UNITED STATES
DEPARTMENT OF THE INTERIOR
BUREAU OF LAND MANAGEMENT
APPLICATION FOR PERMIT TO DRILL OR REENTER

1a. Type of work: ☒ DRILL ☐ REENTER 1b. Type of Well: ☒ Oil Well ☐ Gas Well ☐ Other 1c. Type of Completion: ☐ Hydraulic Fracturing ☒ Single Zone ☐ Multiple Zone		5. Lease Serial No. NMNM0359292 6. If Indian, Allottee or Tribe Name 7. If Unit or CA Agreement, Name and No. NMNM137578/CALM BREEZE 2 FED CO 8. Lease Name and Well No. CALM BREEZE 2 FED COM 754H

PECOS DISTRICT DRILLING CONDITIONS OF APPROVAL

OPERATOR'S NAME:	EOG RESOURCES INCORPORATED
WELL NAME & NO.:	CALM BREEZE 2 FED COM 754H
SURFACE HOLE FOOTAGE:	2207'/S & 391'/W
BOTTOM HOLE FOOTAGE:	100'/S & 330'/W
LOCATION:	Section 2, T.26 S., R.33 E., NMP
COUNTY:	Lea County, New Mexico

Proposed Wellbore

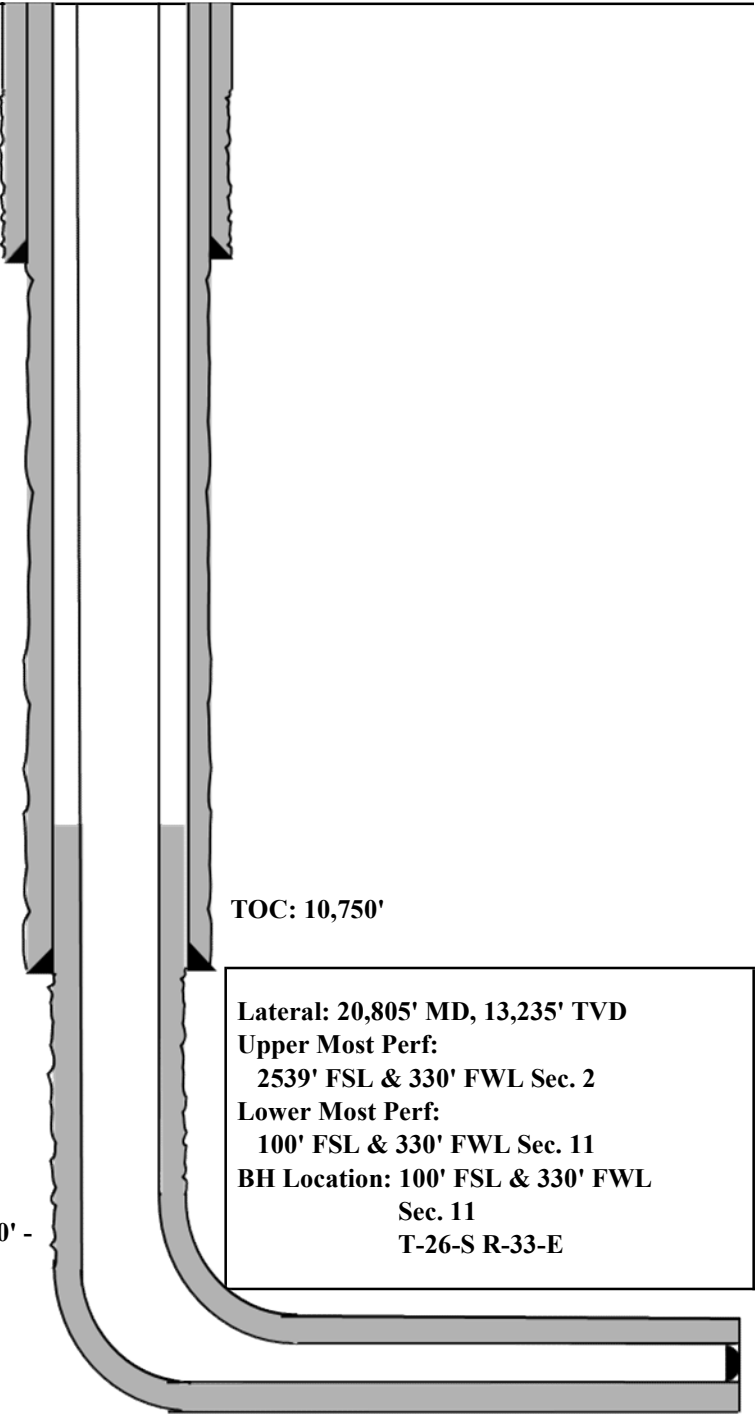
Operator has proposed to pump down 9-5/8" X 7-5/8" annulus after primary cementing stage. Operator must run Echo-meter to verify Cement Slurry/Fluid top in the annulus Or operator shall run a CBL from TD of the 7-5/8" casing to surface after the second stage BH to verify TOC.

3. The minimum required fill of cement behind the 5-1/2 inch production casing is:
 - Cement should tie-back at least **200 feet** into previous casing string due to operator not meeting casing clearance requirement per 43 CFR 3170. Operator shall provide method of verification.
